MINERALS PROGRAM INSPECTION REPORT**PHONE: (303) 866-3567**

MINE NAME: Vasquez Quarry No 2	MINE/PROSPECTING ID#: M-1994-121	MINERAL: Sandstone (silica, stone, quartzite)	COUNTY: Boulder
INSPECTION TYPE: Monitoring	INSPECTOR(S): Amy Eschberger	INSP. DATE: April 6, 2017	INSP. TIME: 10:35
OPERATOR: O & A Stone LLC	OPERATOR REPRESENTATIVE: Arthur Vasquez	TYPE OF OPERATION: 110c - Construction Limited Impact	
REASON FOR INSPECTION: Normal I&E Program	BOND CALCULATION TYPE: Complete Bond	BOND AMOUNT: \$7,670.00	
DATE OF COMPLAINT: NA	POST INSP. CONTACTS: None	JOINT INSP. AGENCY: None	
WEATHER: Clear	INSPECTOR'S SIGNATURE: 	SIGNATURE DATE: June 1, 2017

M1994-121 / Vasquez Quarry No. 2 / O & A Stone LLC

Red Outline = 7.4 acres = Approved Permit Area

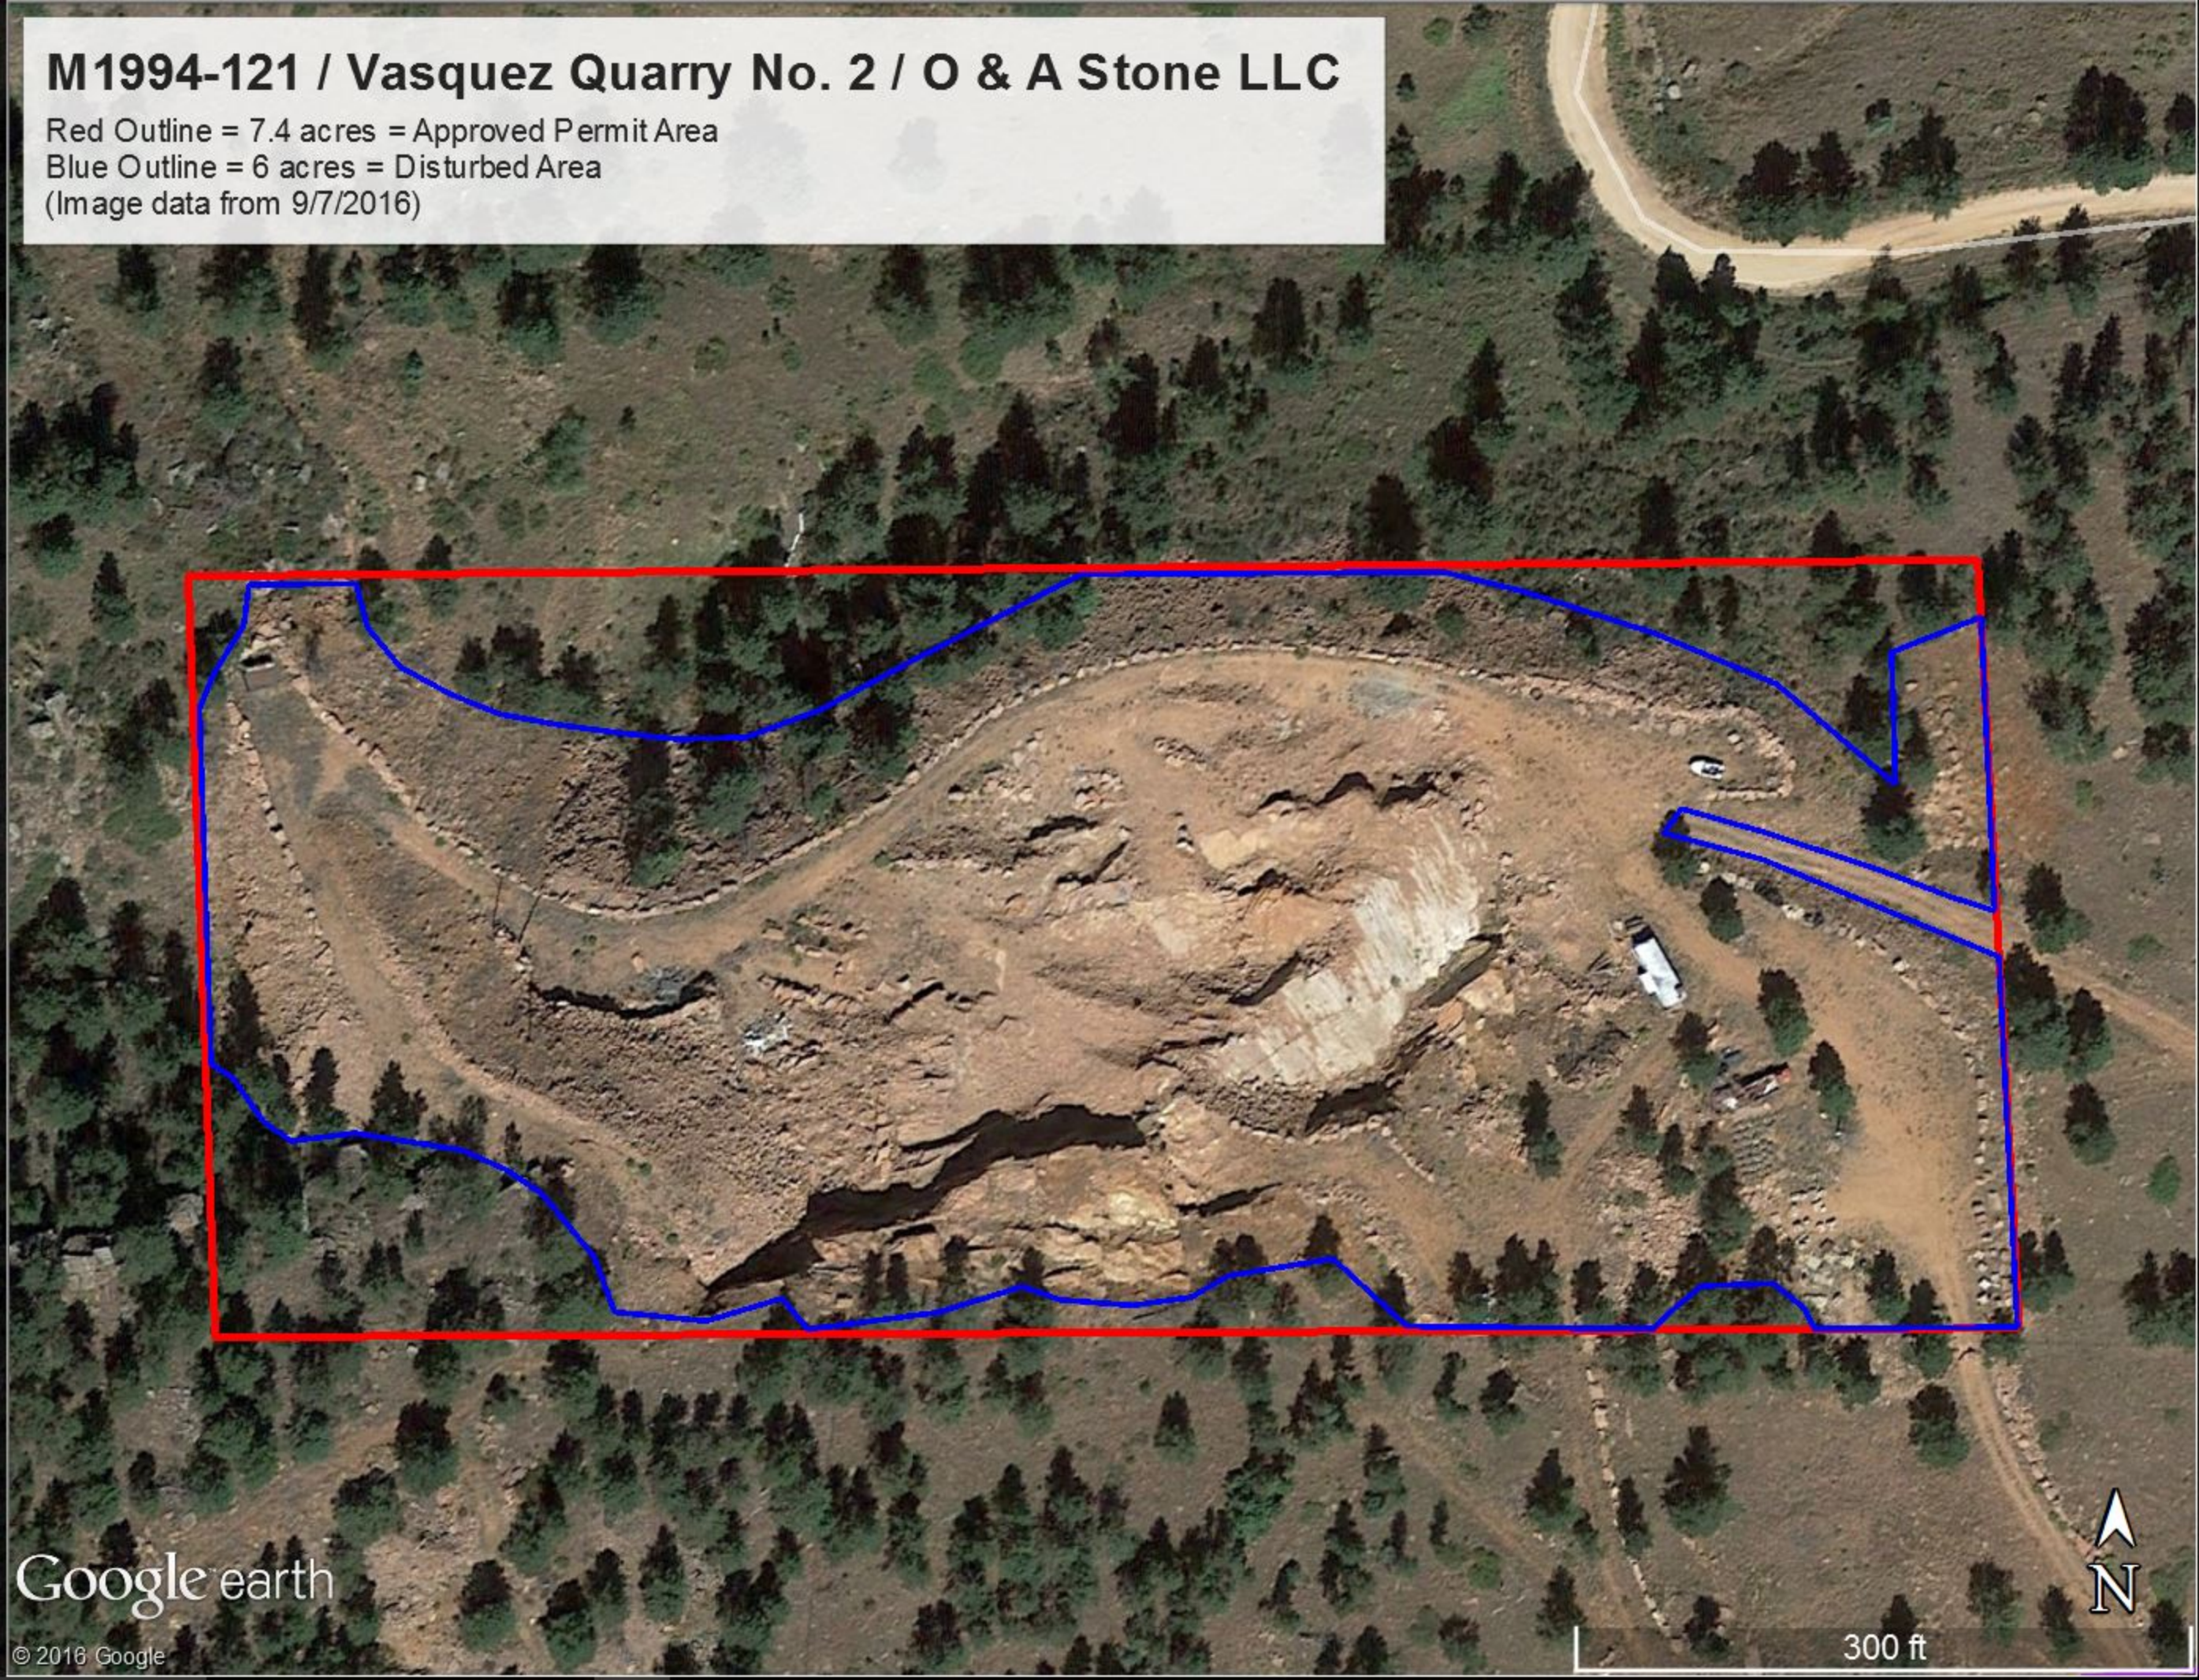
At the time of the inspection, it was clear and sunny, and the ground was dry. The site was not active during the inspection. However, Mr. Vasquez indicated the site is active every year, which is in compliance with its intermittent status. The permit boundary was delineated with posts. The Division estimates the operation has disturbed a total of 6 acres (see enclosed Google Earth image of site; also see **Photos 1-6**), including internal haul roads, a topsoil stockpile at the eastern edge of the site, a large overburden/waste rock stockpile at the western edge of the site, a stone and equipment storage area in the southeastern portion of the site, and a highwall along the southern edge of the site that is approximately 460 feet in length and up to 30 feet in height. The portion of the access road that enters the permitted area was constructed on existing overburden/waste rock stockpiles created before the site was permitted. The disturbance area is on or very close to the northern, eastern, and western permit boundaries. The current highwall is within 25-100 feet of the southern permit boundary. Therefore, the Division strongly recommends the operation be very cautious in extending disturbance, especially where the highwall is within 25 feet of the southern permit boundary, to avoid causing offsite damage.

During the inspection, Mr. Vasquez indicated his intention to use the overburden/waste rock stockpiled on site for backfilling the highwall during reclamation. The Division encourages the elimination of highwalls whenever possible, as it provides a more stable post-mining topography. However, the current approved reclamation plan for the site does not include backfilling highwalls. To revise the reclamation plan to include backfilling highwalls with overburden/waste rock stored on site, the operator would need to submit a Technical Revision (see enclosed form). In review of the Technical Revision, the Division would recalculate the required Financial Warranty for the site. The operator should be advised that adding costs for backfilling the highwall would increase the required financial warranty.
